CONSERVATION & DESIGN COMMENTS

Application No: 23/00908/FLH	Date of comment: 4.10.2023
Location: 21 The Headway Ewell Surrey KT17 1UN	
Proposal: Landscaping alterations to front driveway incorporating entrance gates and scrubs fencing to property boundary. Swimming pool to rear garden.	
Conservation area: Ewell Village with Article 4 Direction	
Consultee: Justine Page	
Site visit: 3.10.2023

Drawing ITE-201028-PS-001 - Proposed Ground Floor Layout Drawing v15 - 21/01807/FLH

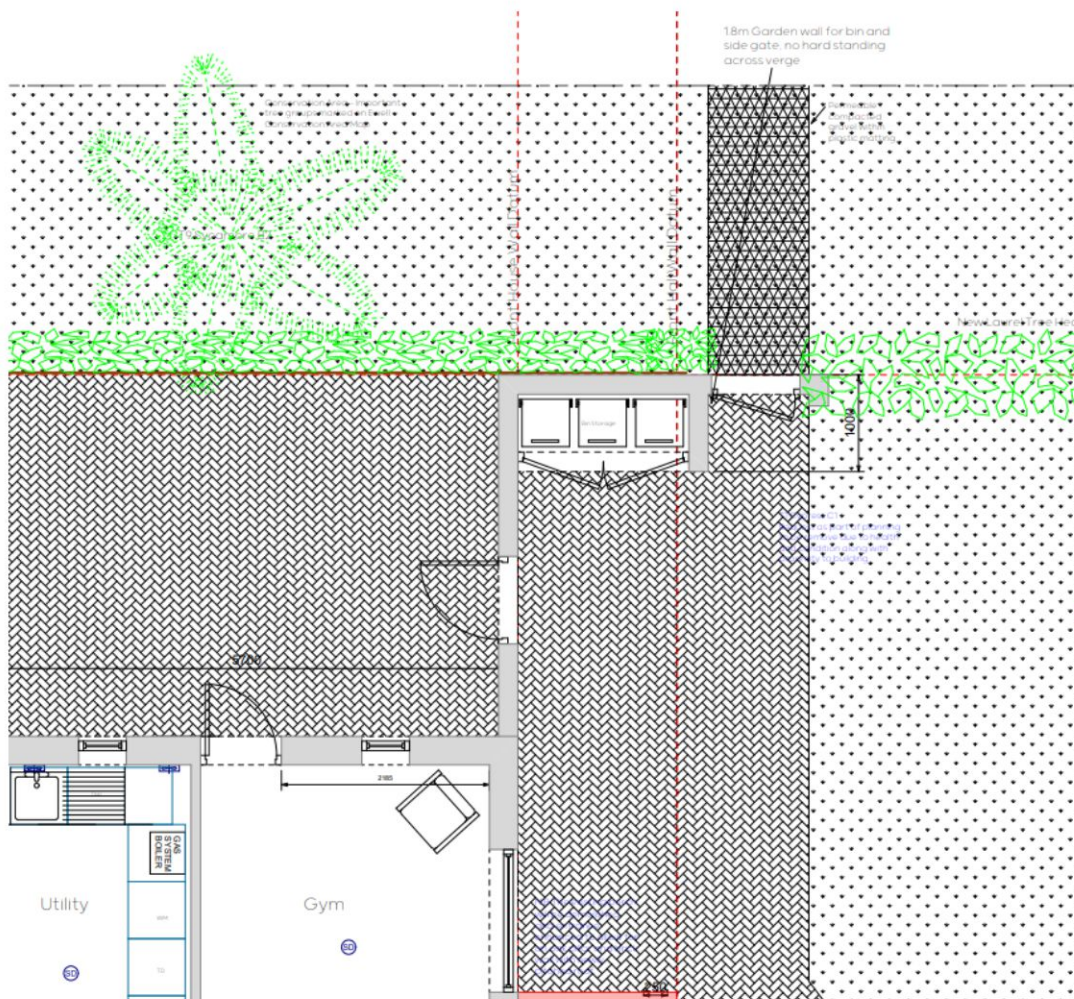
I think the existing plan is incorrect and shows more paving that actually exists on site, especially to the right of the front door where there is just a path to the gate. I would not object to an additional driveway into the front garden if **a)** the size was reduced to a minimum and **b)** the harm was counter balanced by resurfacing with a more sympathetic material such as buff / brown gravel which has a softer appearance and is more in keeping with other gravel driveways in the immediate area.

The new piece of wall shown below is unauthorised and projects into the front garden so also serves to block and harm the open character of the area.

AGENT REPLY: Your comments are noted, but it should be made clear that under planning application 21/01807/FLH Full Granted Planning Permission included the construction of the path and wall entering the property from this side seen on drawing "ITE-201028-PS-001 - Proposed Ground Floor Layout Drawing" of 21/01807/FLH, for which should then be considered as part as the existing and not part of this new application as this has already been granted on the first planning application. A small extract of drawing "ITE-201028-PS-001 - Proposed Ground Floor Layout Drawing" can be seen below, however please check your records with regards to application 21/01807/FLH. In this application 23/00908/FLH and reflected on the drive area that was amended as part of 21/01807/FLH but under this application a consideration would need to be amended further. Hence the driveway area that has been increased is the minimum to be able to navigate a car in and out of the drive, for which has been considered to ensure as much lawn is retained. With regards to the surface of the driveway, understandably this permeable block paving is currently part of the existing surface and my client considered not to change the surface to allow for it to be continued as the same as existing under the planning rules of matching existing character and material in line with the regulations. My client is looking to not disturb the existing driveway and the expense that this will bring but to clean and add to the area as indicated on the drawing. Moving to a loose gravel would be very different to the majority of the houses in the road with examples seen in the road such as slab, block, resin and natural non permeable tiles all being used on The Headway.

Finally to be completely clear the new wall, opening and path as below should NOT be part of this application and considered as being non permitted, as mentioned above this has been accepted and granted as part of 21/01807/FLH and should not be objected to as part of this planning application.
